CHAIR: ROBERT GROHMANN
MEMBER: JIM SARCLETTI
MEMBER: DAN LESHER
MEMBER: MIKE SHERMAN
MEMBER: TINA ZELLMAN
ALTERNATE MEMBER: J.D. LUDFORD

Meeting Date:		May 5, 2022				
Item Name:		Site Plan & Design Review - Waconia Fire Station				
Originating Department:		Community Development				
Presented by:		Lane Braaten				
Previous Council Action (if any):						
Item Type (X only one):	Consent		Regular Session	X	Discussion Session

Provide a recommendation to the City Council regarding the Site Plan & Design Review application to construct a new fire station at 10451 10th Street West.

The applicant, on behalf of the City of Waconia, has submitted an application for Site Plan and Design Review for the property located at 10451 10th Street West. The application proposes the construction of a new fire station on the subject parcel.

1
A010
ARCHITECTURAL SITE PLAN
1" = 20'-0"

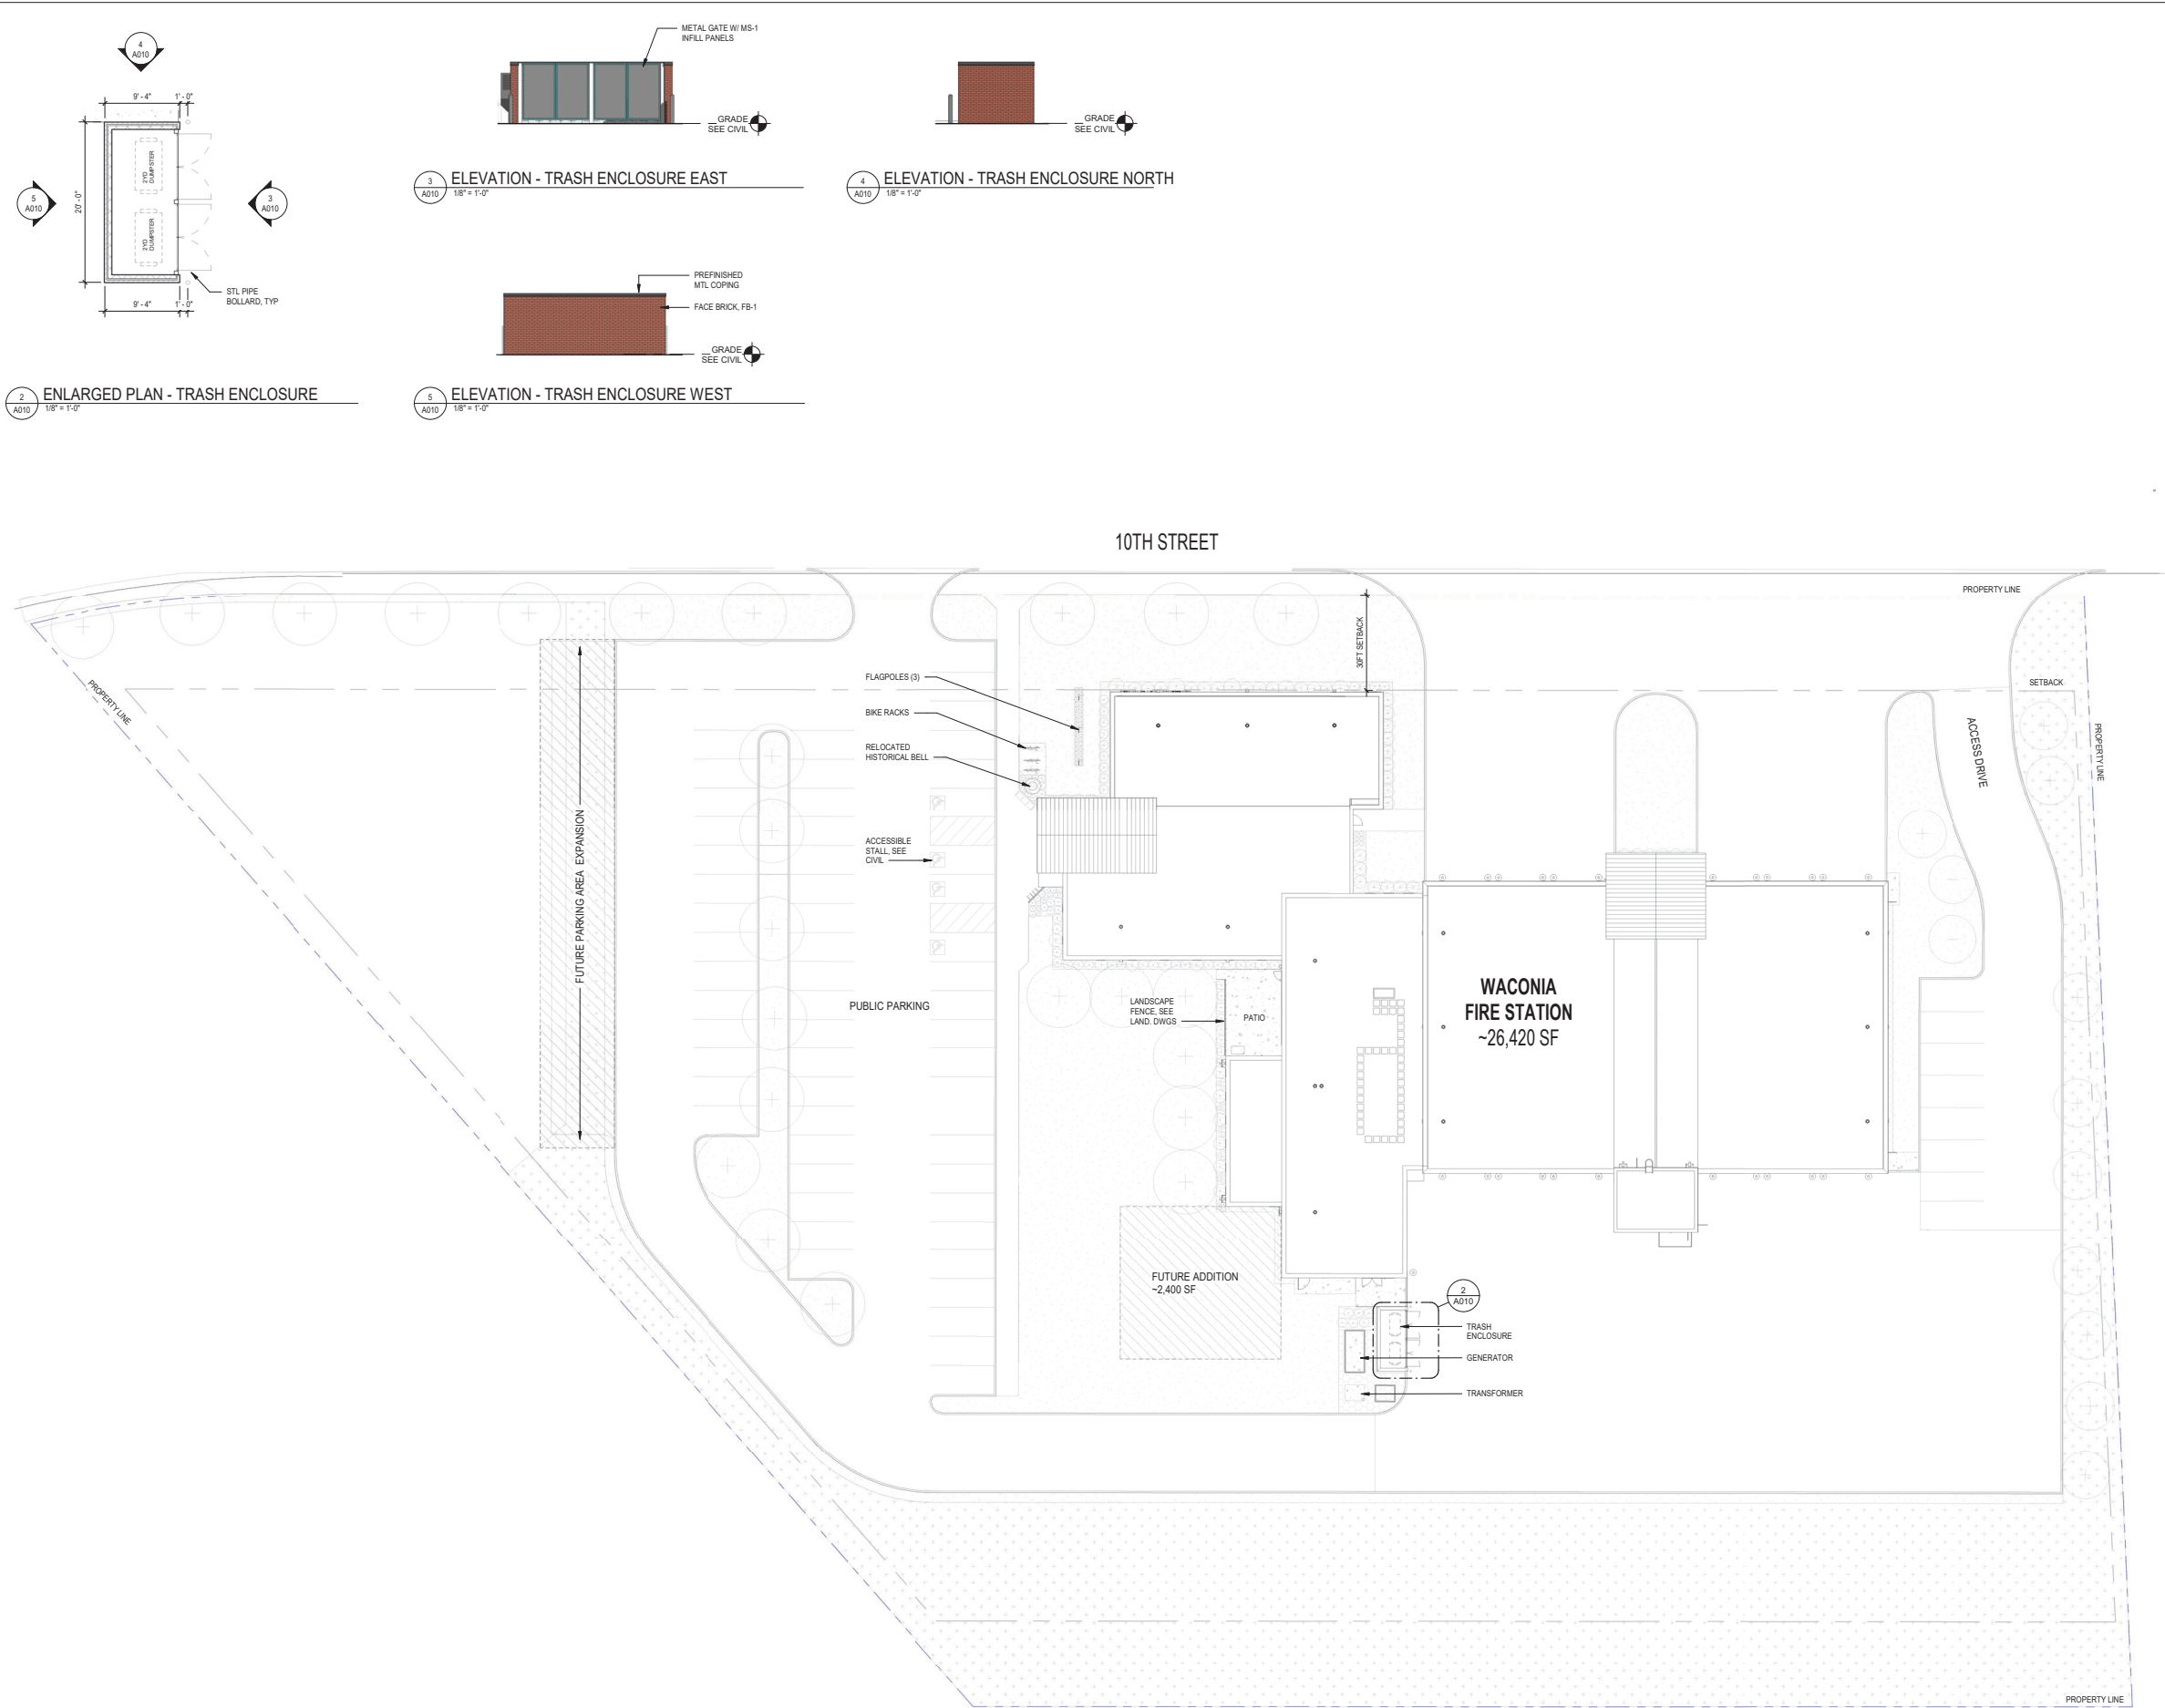
The structure setbacks, building height, and hardcover surface requirements stated above have been satisfied based on a review of the Architectural Site Plan – A010 dated April 7, 2022, the Site Plan – C1.21 dated April 7, 2022 and the Exterior Elevations – A401 dated April 7, 2022.

The plan identifies the construction of 64 surface parking spaces and area for seventeen (17) additional parking spaces to be constructed at a future date. The Planning Commission should review this information and discuss the proposed parking with BKV Group to better understand the proposed parking.

EXTERIOR
ELEVATIONS

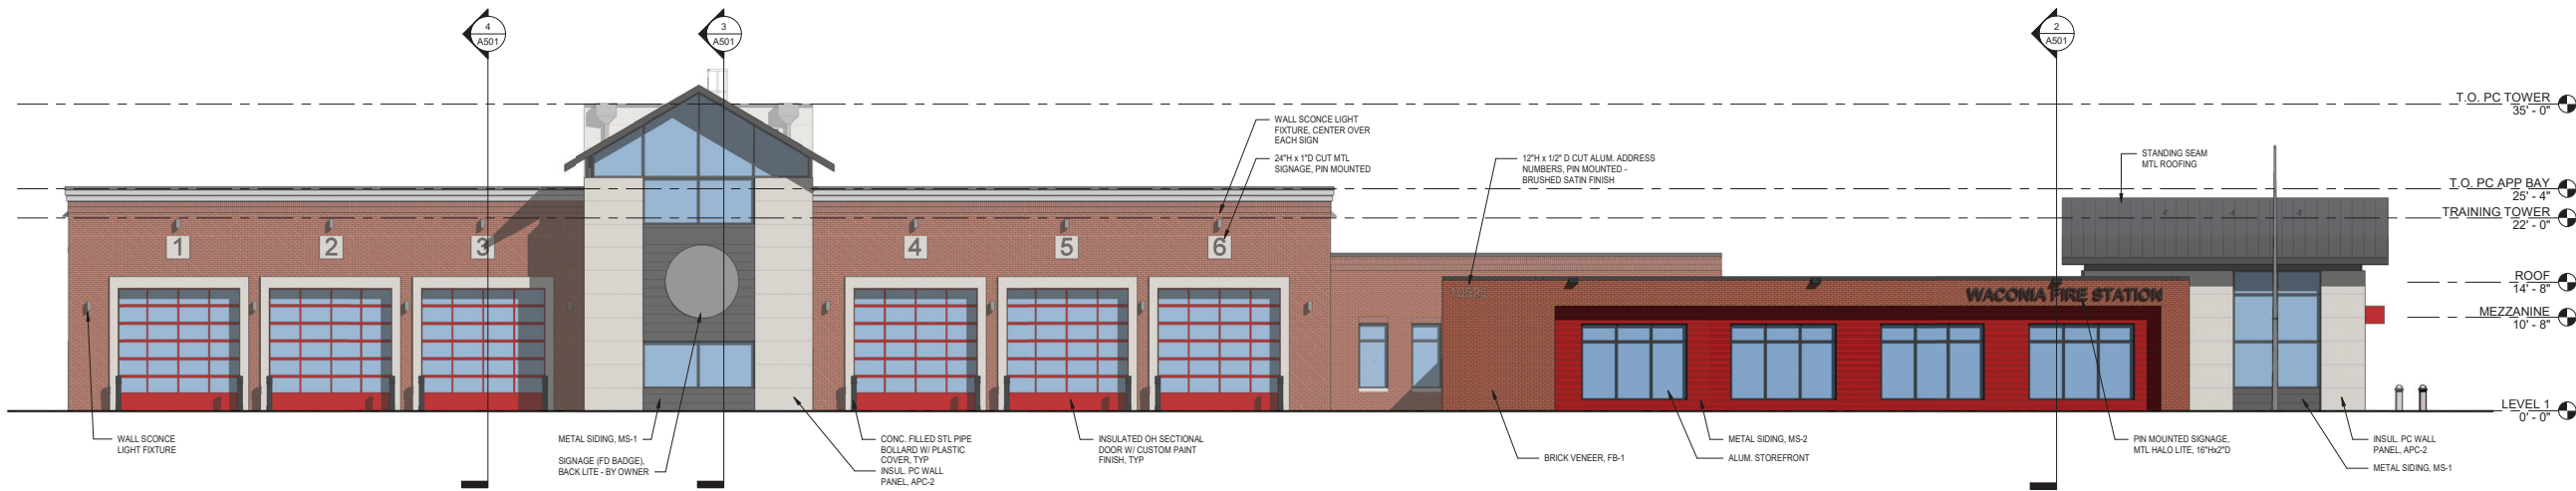
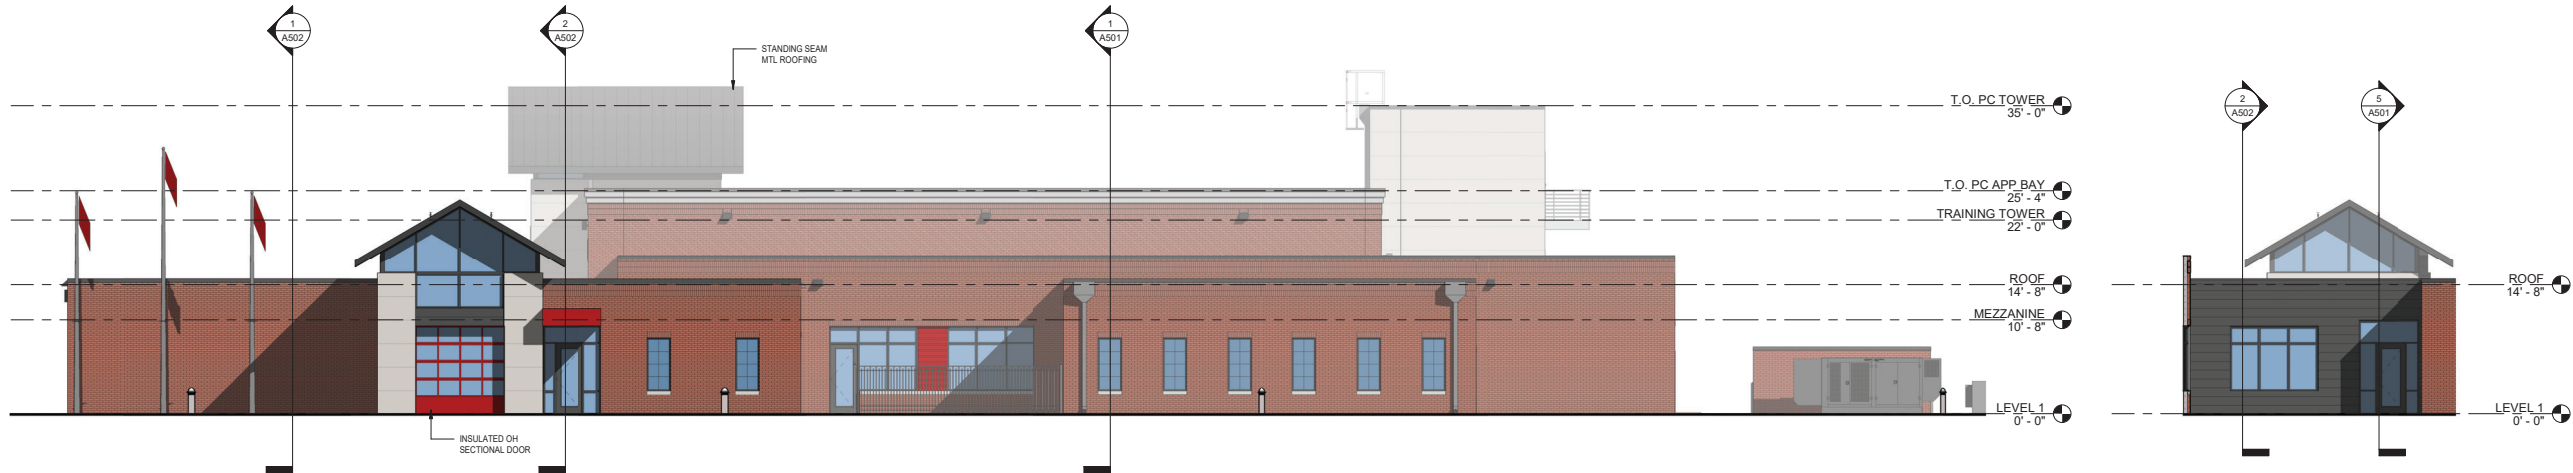
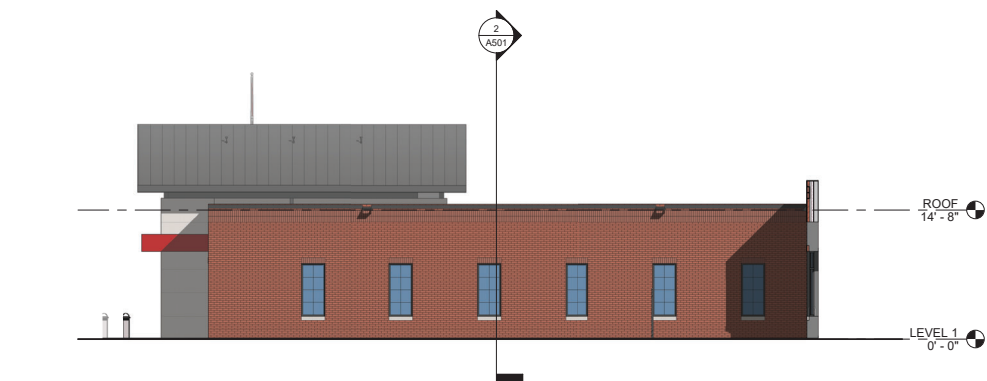
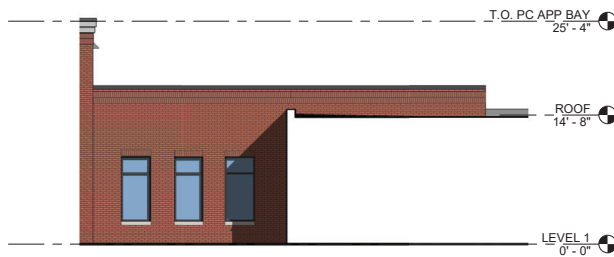
The plans indicate some wall signage, but does not provide specific dimensions. Signage appears to generally meet City Code, however separate sign permits, and review are still required.

Based on a review of the plan set provided by the applicant for the fire station, staff finds that the building design requirements stated in the Industrial Design District meets the City Industrial District Design standards.

1
L100
OVERALL SITE LANDSCAPE PLAN
1" = 20'-0"

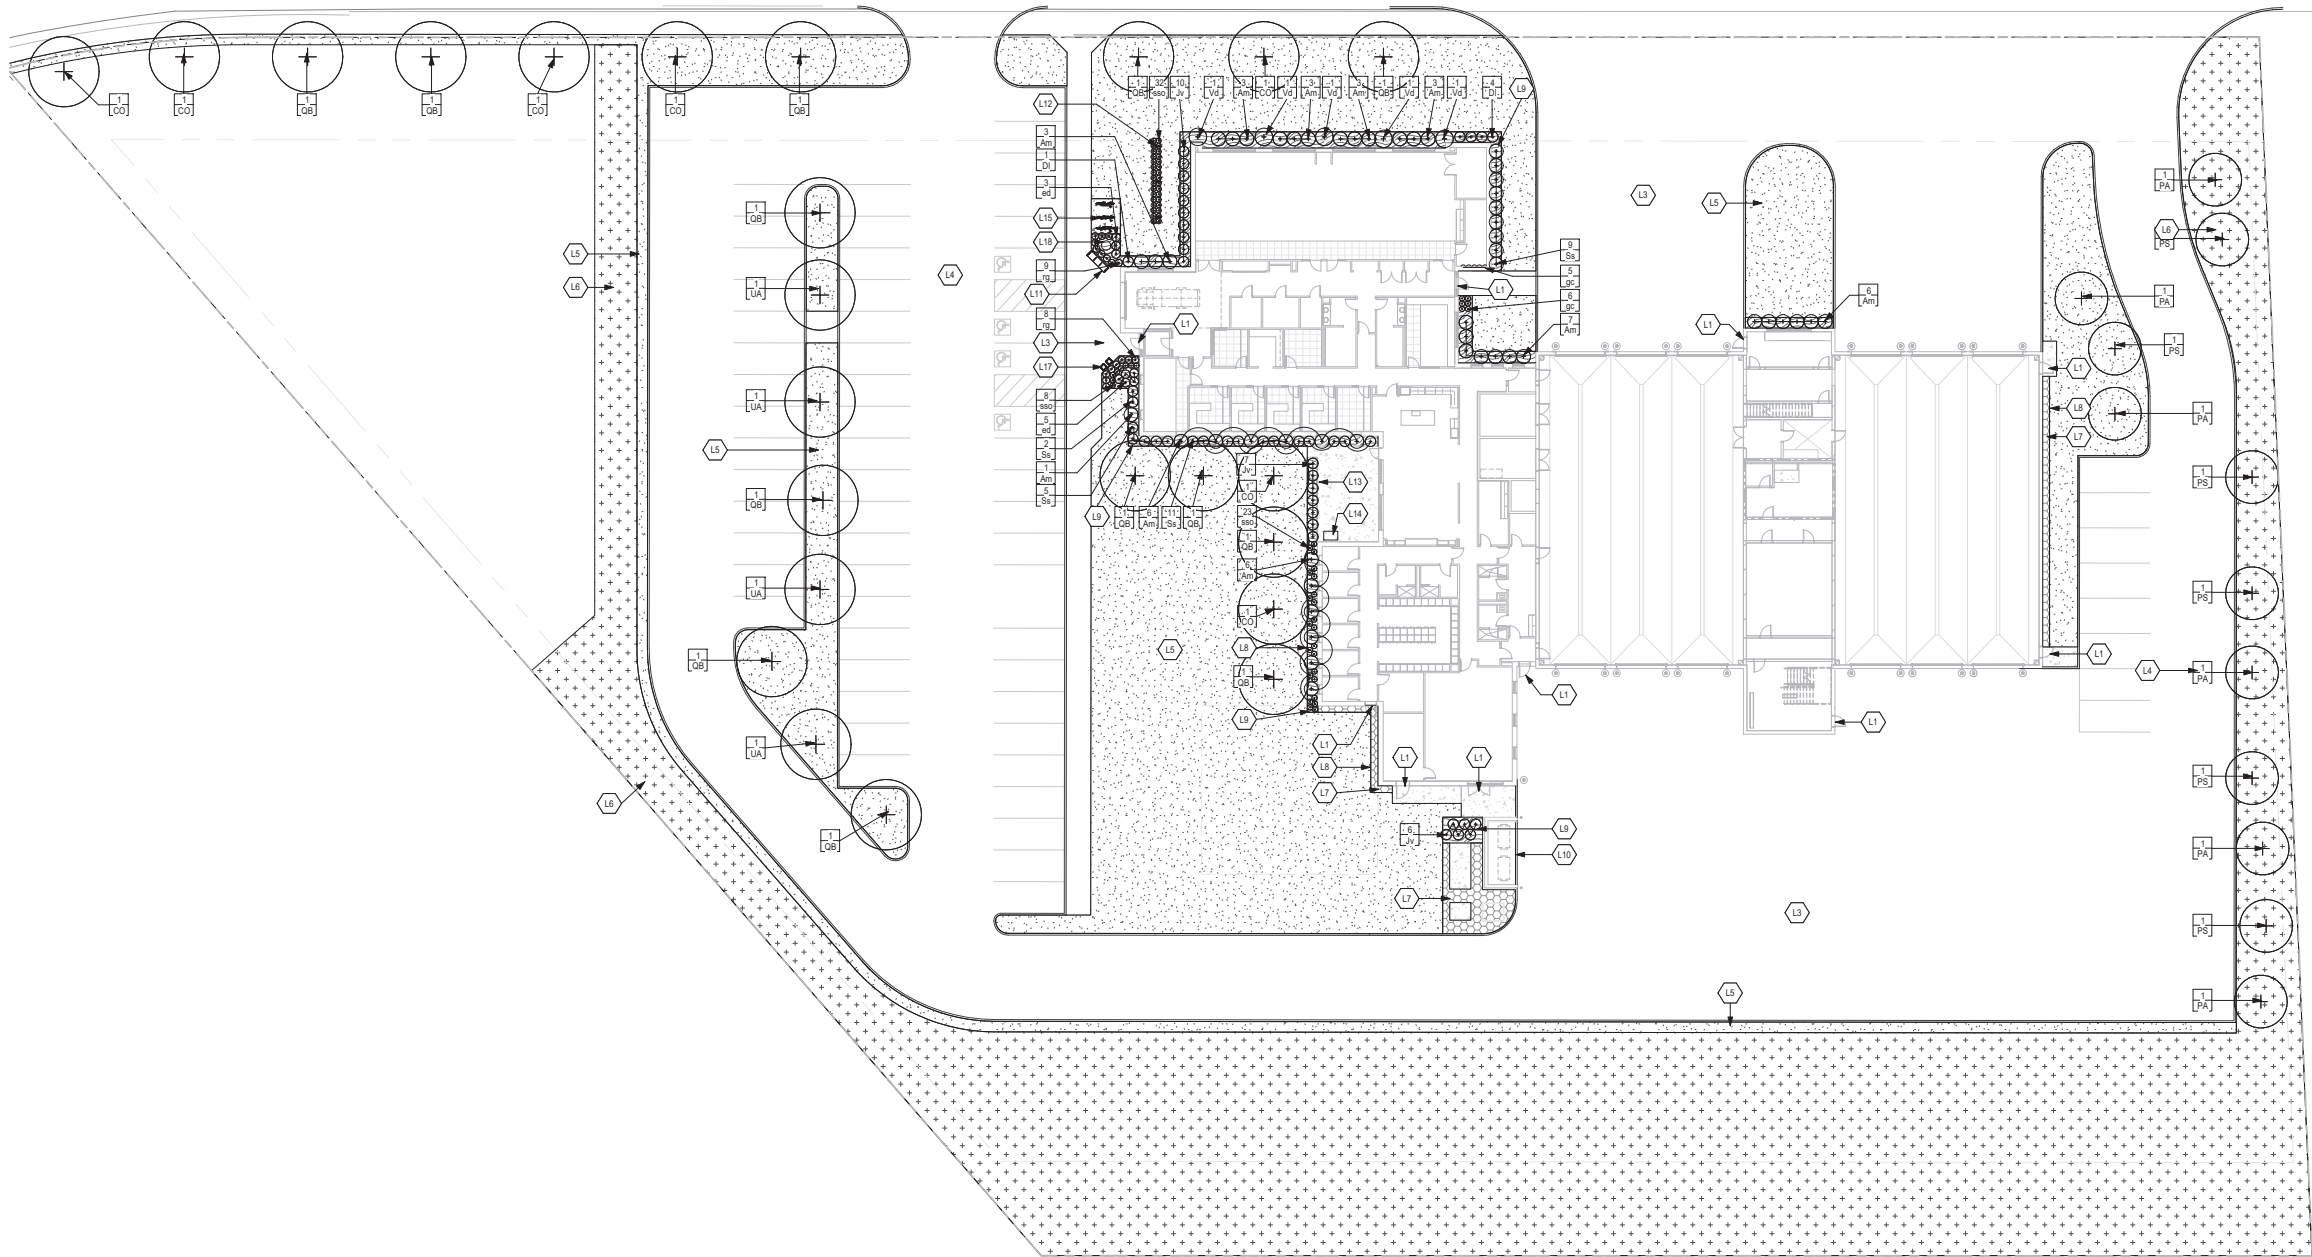
The proposed fire station is approximately 26,420 square feet, which would require a minimum of twenty-seven (27) trees to be planted on site. The landscape plan includes the planting of thirty-six (36) trees on site along with shrubs, perennials, grasses and other groundcover. The landscape plan conforms to City Code requirements.
